ADDENDUMS / REVISIONS	
ADDENDUM NO. $\Delta$	REVISED GRADING
5/17/2013, RLS

**INDIAN RIVER INLET  
PARK ENHANCEMENTS**

**GRADES AND GEOMETRICS  
GRADING PLAN  
(BASE BID)**

UT04
SHEET NO.
171
TOTAL SHTS.
282

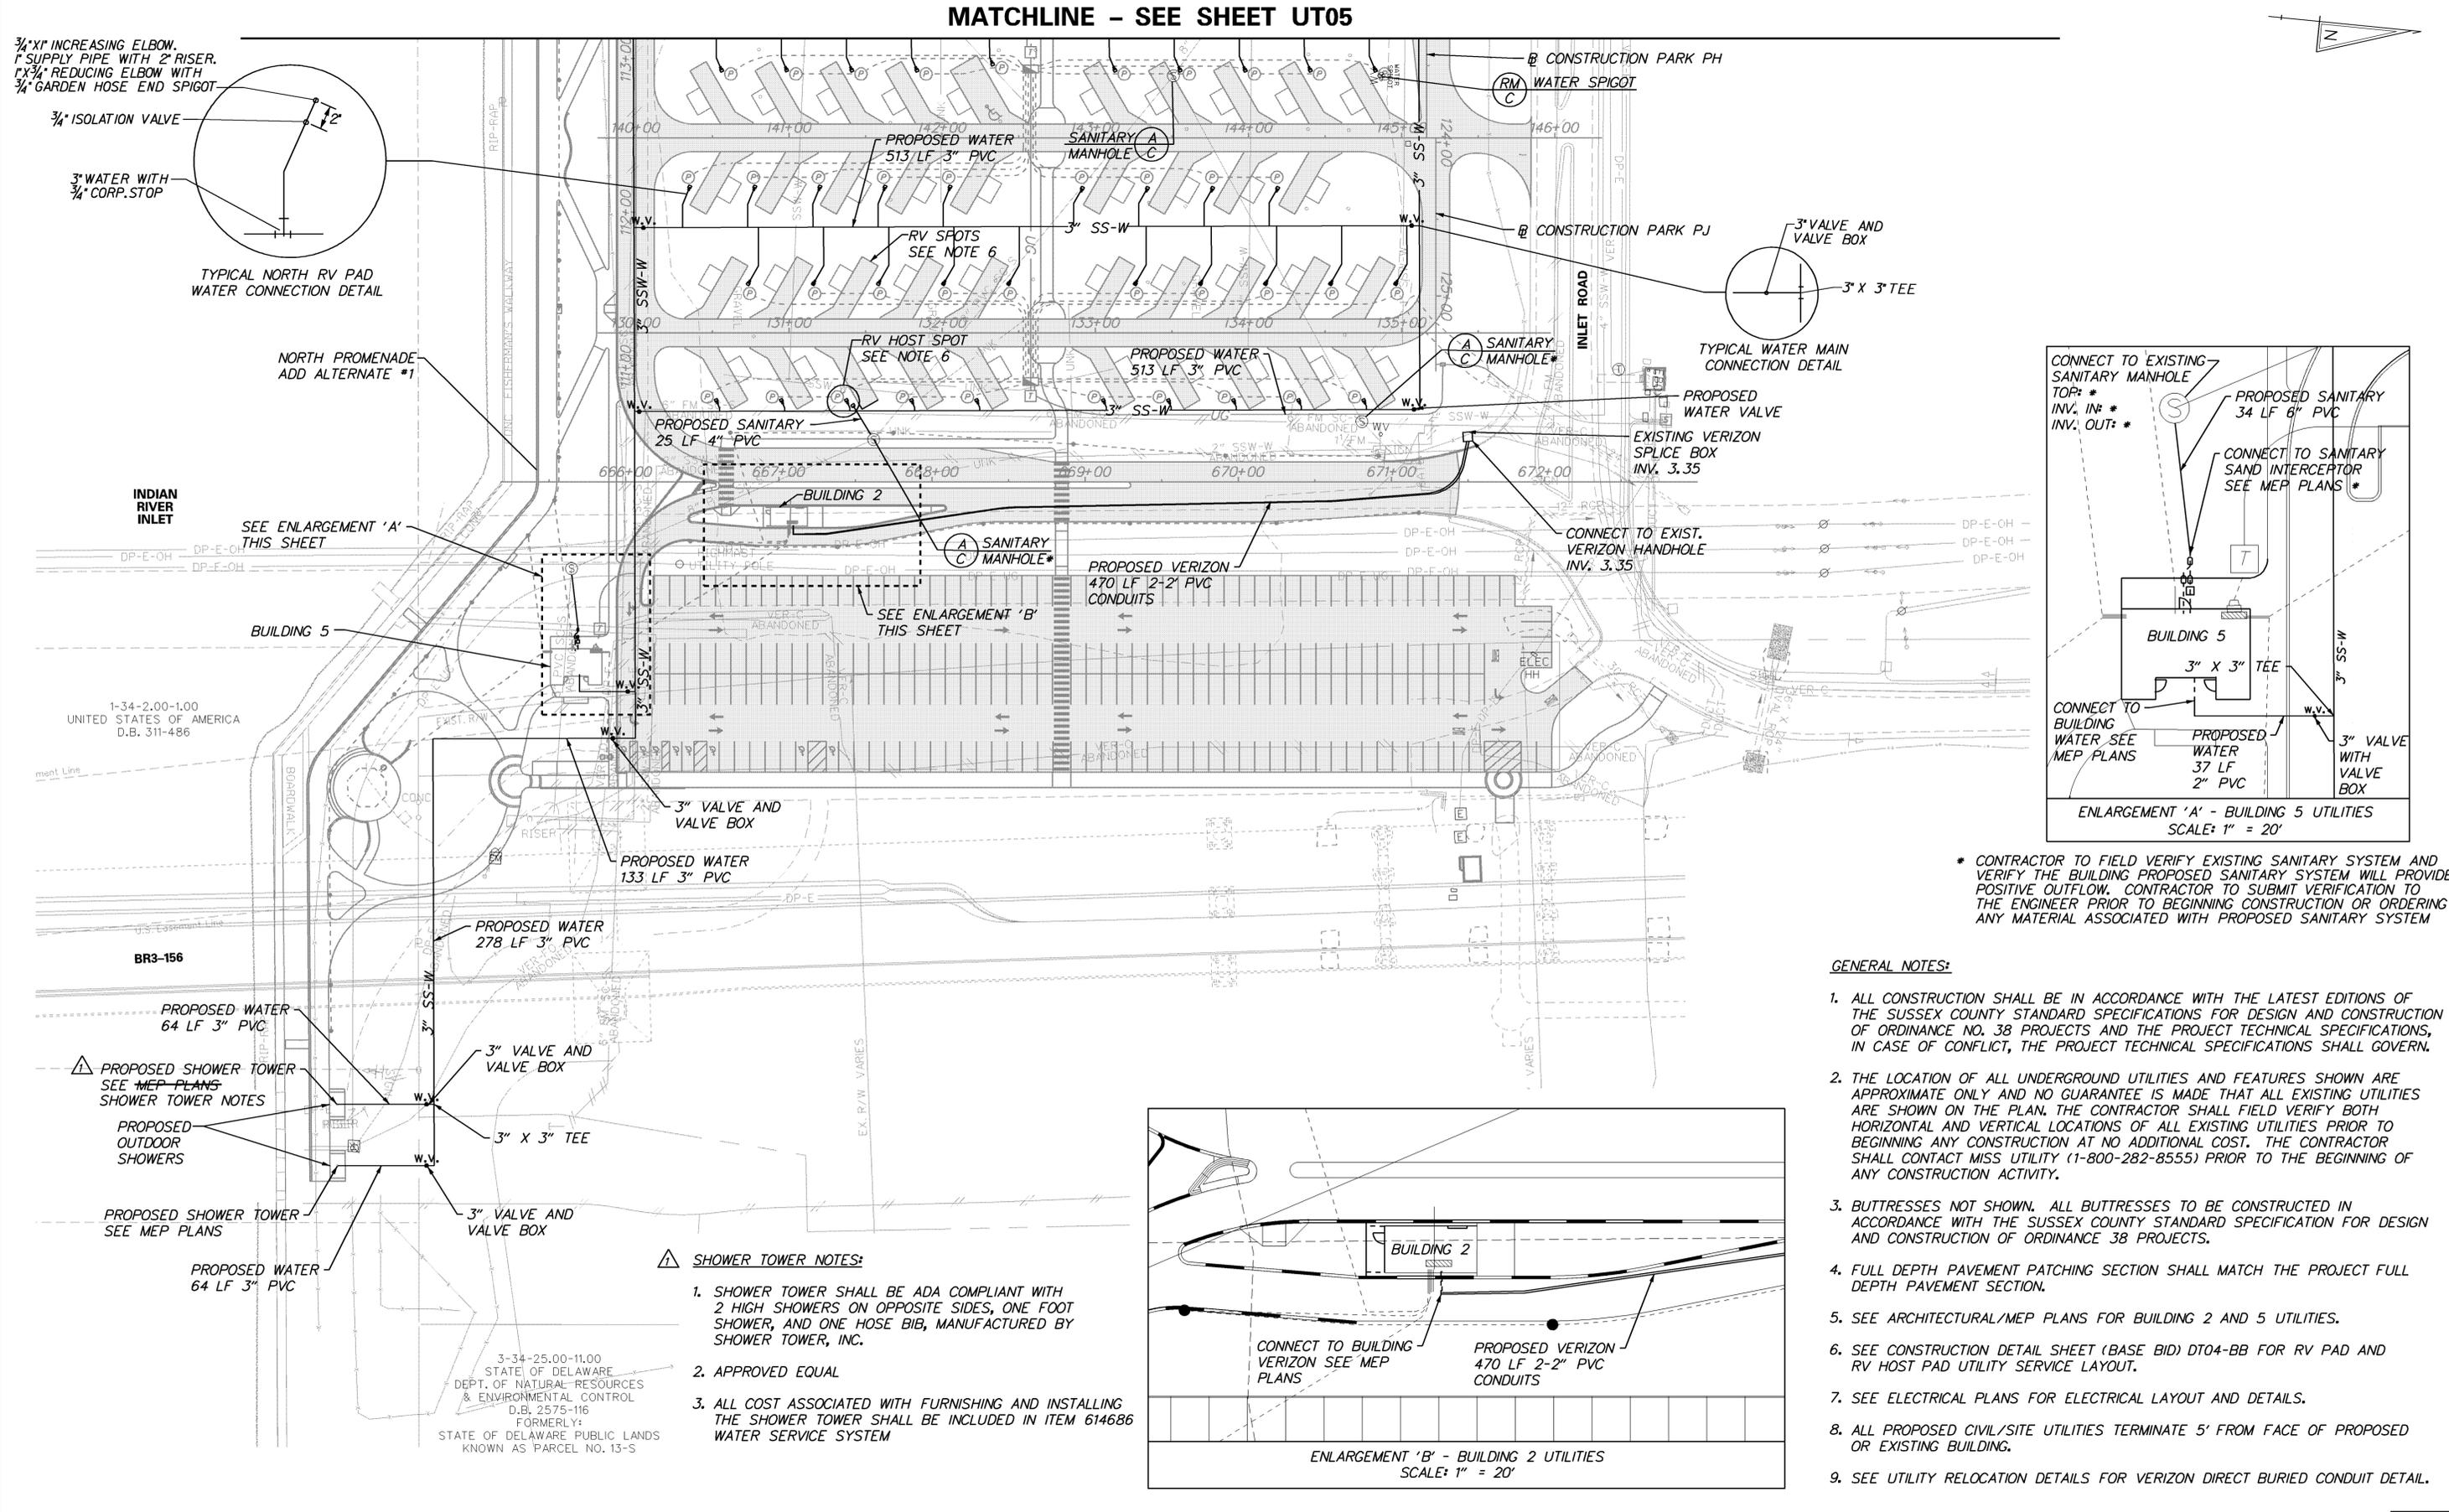
ADDENDUMS / REVISIONS	
ADDENDUM NO. 1	REVISED/ADDED NOTES
5/17/2013, RLS

\* CONTRACTOR TO FIELD VERIFY EXISTING SANITARY SYSTEM AND VERIFY THE BUILDING PROPOSED SANITARY SYSTEM WILL PROVIDE POSITIVE OUTFLOW. CONTRACTOR TO SUBMIT VERIFICATION TO THE ENGINEER PRIOR TO BEGINNING CONSTRUCTION OR ORDERING ANY MATERIAL ASSOCIATED WITH PROPOSED SANITARY SYSTEM

6. SEE CONSTRUCTION DETAIL SHEET (BASE BID) DT04-BB FOR RV PAD AND RV HOST PAD UTILITY SERVICE LAYOUT.
7. SEE ELECTRICAL PLANS FOR ELECTRICAL LAYOUT AND DETAILS.

8. ALL PROPOSED CIVIL/SITE UTILITIES TERMINATE 5' FROM FACE OF PROPOSED OR EXISTING BUILDING.
9. SEE UTILITY RELOCATION DETAILS FOR VERIZON DIRECT BURIED CONDUIT DETAIL.

<b>UTILITY RELOCATION PLAN (WATER, SEWER, VERIZON)</b>	
SHEET NO.	172
TOTAL SHTS.	282

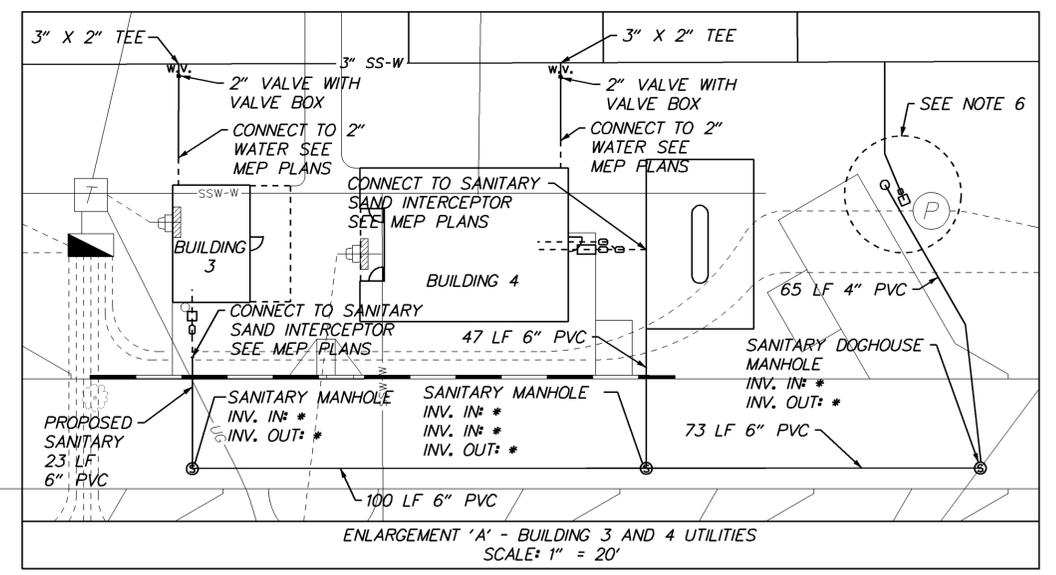
ADDENDUMS / REVISIONS	
ADDENDUM NO. $\Delta$	REVISED/ADDED NOTES
5/17/2013, RLS

\* CONTRACTOR TO FIELD VERIFY EXISTING SANITARY SYSTEM AND VERIFY THE BUILDING PROPOSED SANITARY SYSTEM WILL PROVIDE POSITIVE OUTFLOW. CONTRACTOR TO SUBMIT VERIFICATION TO THE ENGINEER PRIOR TO BEGINNING CONSTRUCTION OR ORDERING ANY MATERIAL ASSOCIATED WITH PROPOSED SANITARY SYSTEM

- SEE CONSTRUCTION DETAIL SHEET (BASE BID) DT04-BB FOR RV PAD AND RV HOST PAD UTILITY/SERVICE LAYOUT.
- SEE ELECTRICAL PLANS FOR ELECTRICAL LAYOUT AND DETAILS.

**1 SANITARY RISER**  
P4-03 SCALE: NONE

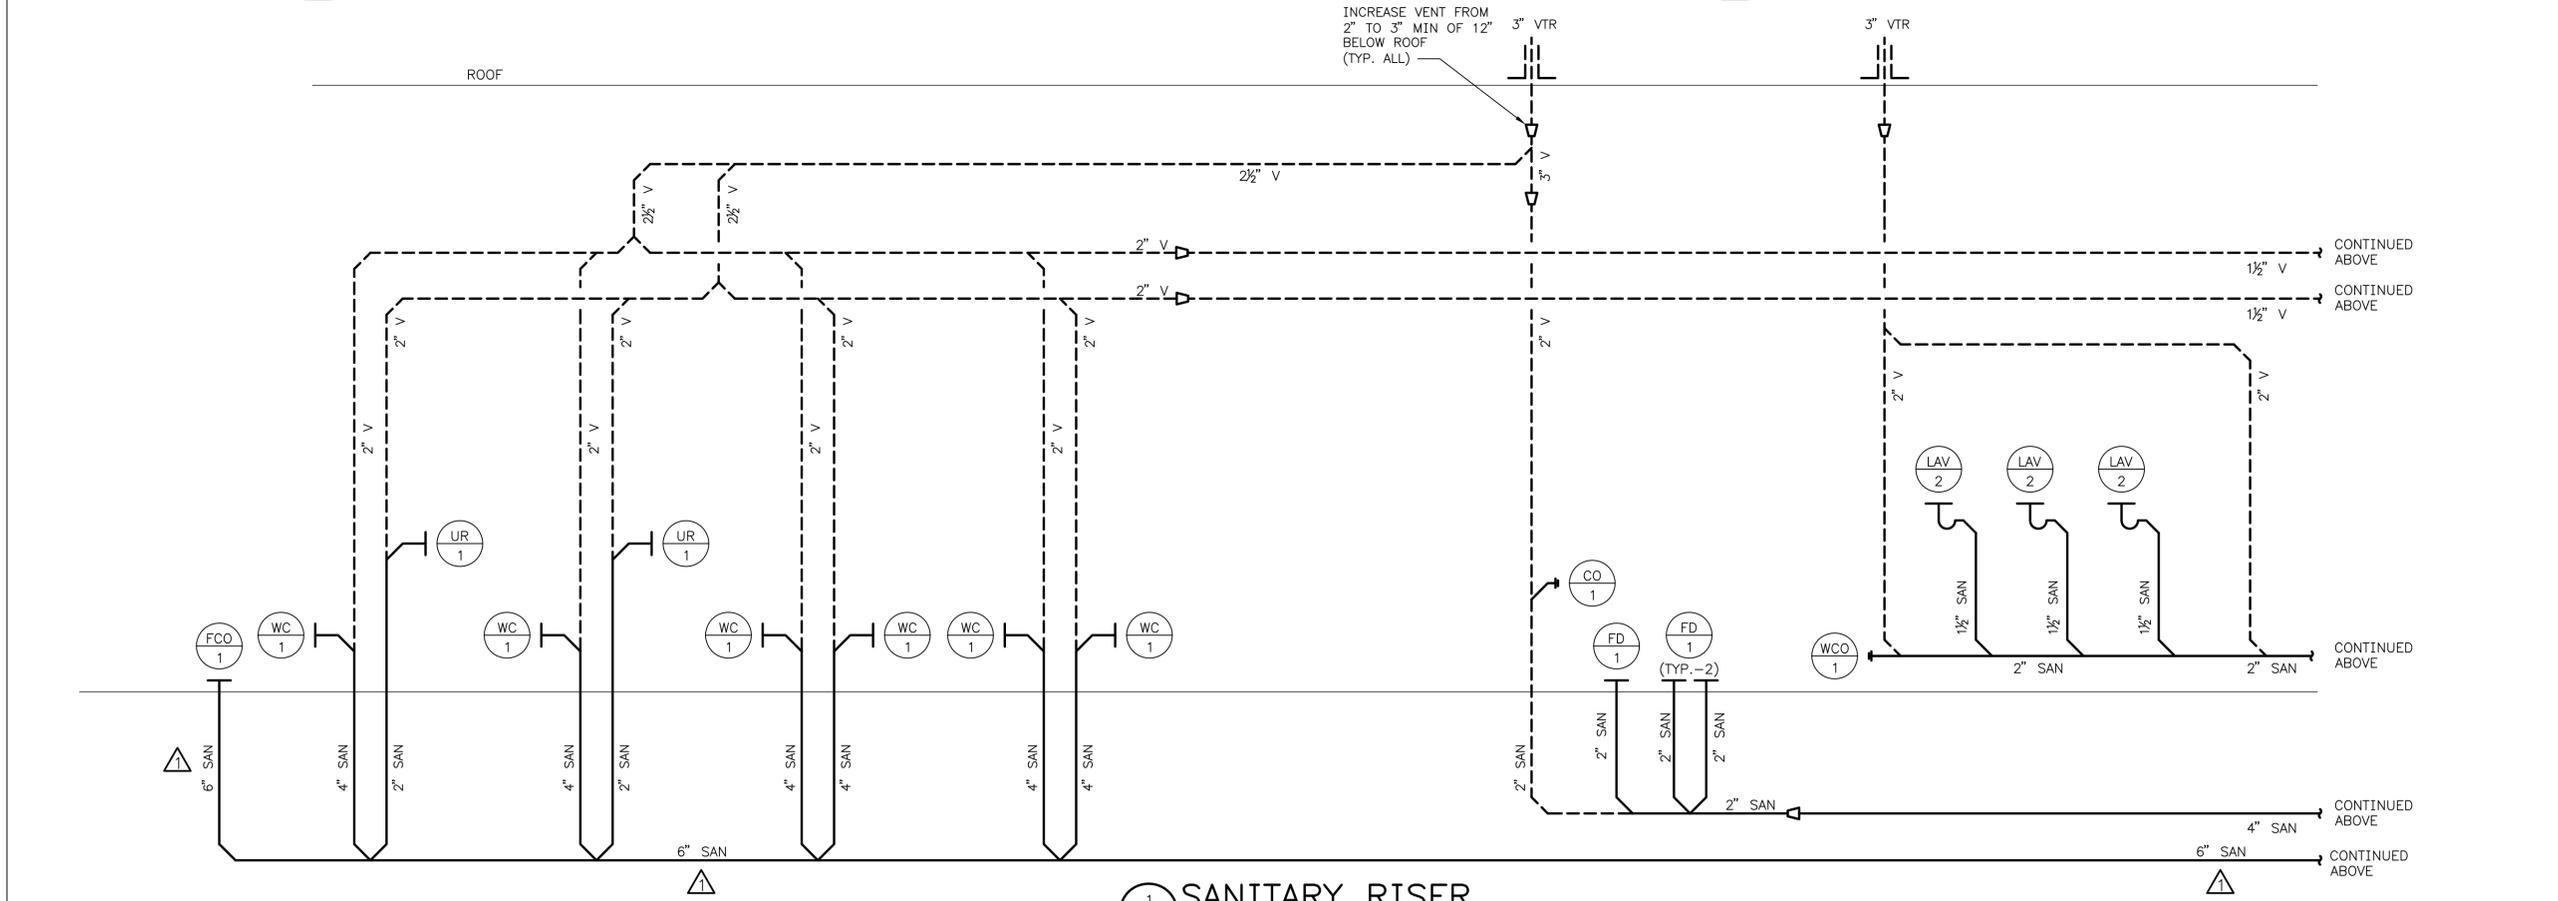
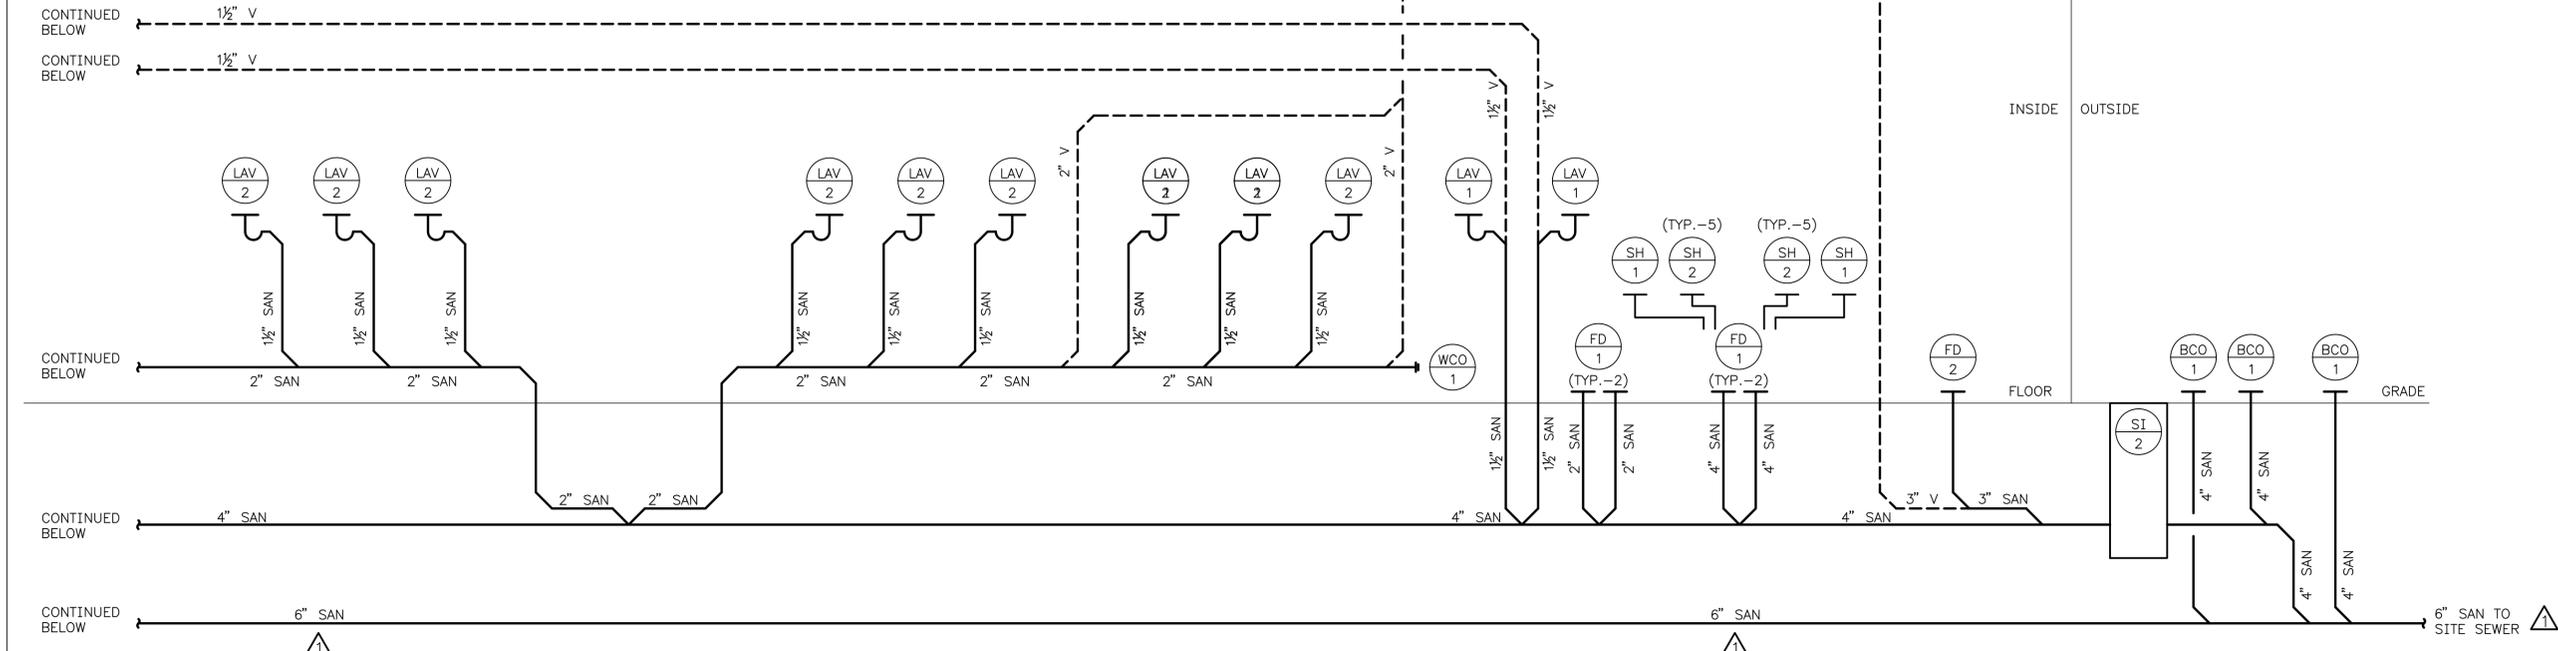
INCREASE VENT FROM 2" TO 3" MIN OF 12" BELOW ROOF (TYP. ALL)

ADDENDUMS / REVISIONS		
▲ INCREASED UNDERGROUND SANITARY MAIN TO 6"	MLF	5/17/13
